A summary of the changes to the RE-909 Rev2 boards.

We have made some minor changes to the RE-909 boards and would like to inform you about them. They are basically just some board printing corrections and improvements.

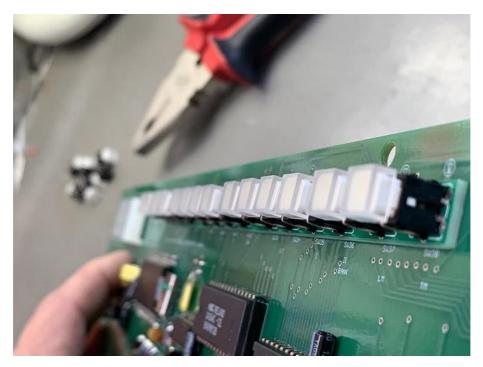
The biggest change concerns the sequencer board:

Here we now **use different LED switches**, which not only look better, but they have a different height than the switches of the first version. They also let you remove the button caps and they are translucent (Ice). We also made **adapter boards** to raise the height of the LED pushbuttons by another **1.6 millimeters**. This makes the keycaps of the step-buttons a bit lower, which of course looks much better. **An updated assembly instruction for the Rev2 sequencer board is available**. The instructions for the Rev1 boards remain valid.

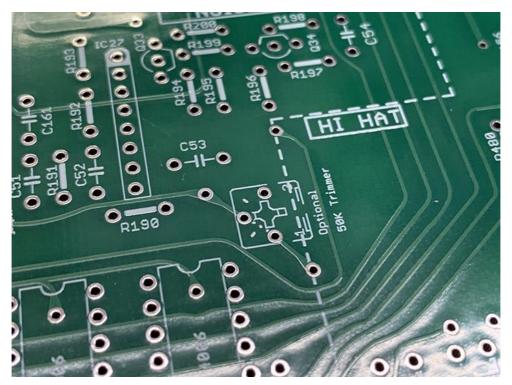
The next change concerns the audio board:

Here we have created additional space for the 10nF film capacitors. This eliminates the fiddling with capacitors on the bottom side of the circuit board.

With trimmer:

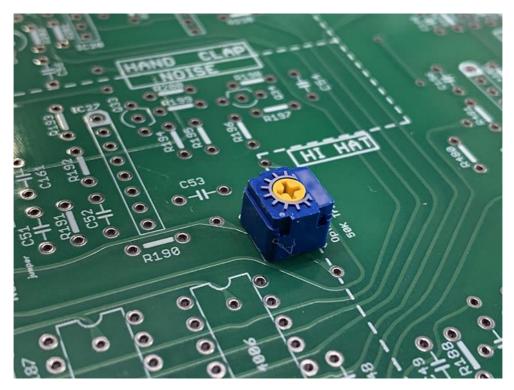
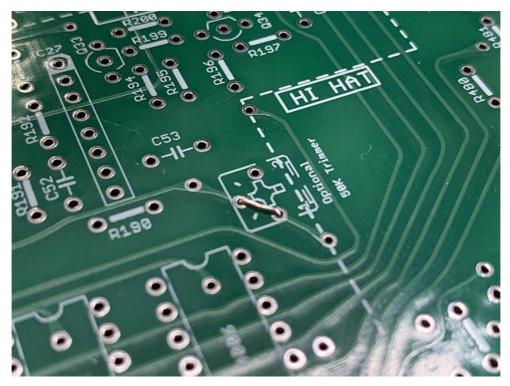
Another change concerns the voiceboard:

Here it's basically **minor changes** and corrections in the platinum print.

First of all, we have created a possibility in the path for the white noise signal to be able to use a **50KB trimmer** if it happens that the noise signal is **too strong** and snare or clap noise too much. Lowering the noise signal with a trimmer **makes more sense** than changing the components in snare or clap. This way it is

possible to adjust the signal strength as desired.

If someone does **NOT** want to use this trimmer and **prefers to fiddle in the components** of the instruments, he simply sets a jumper at this point. **The trimmer makes things easier... try it out!**

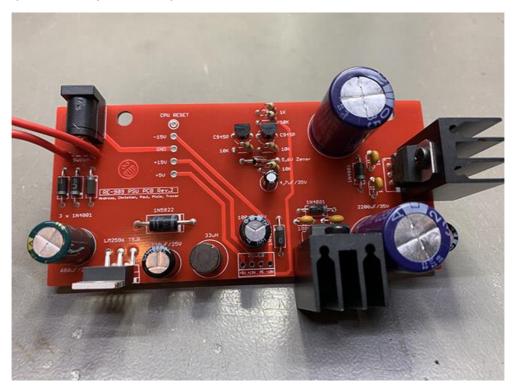
Another change concerns the Safety PSU:

We have changed the PCB so that all cooling elements are now located on the outside and thus normal sized heatsinks can be used. In addition, the boards have been optimized to accept the **Wakelfield-Vette** heatsinks, which have two solderable retaining pins. The initial startup problem of the CPU on the sequencer board due to a wrongly controlled diode has been solved. **An updated assembly manual incl. parts list is available.**
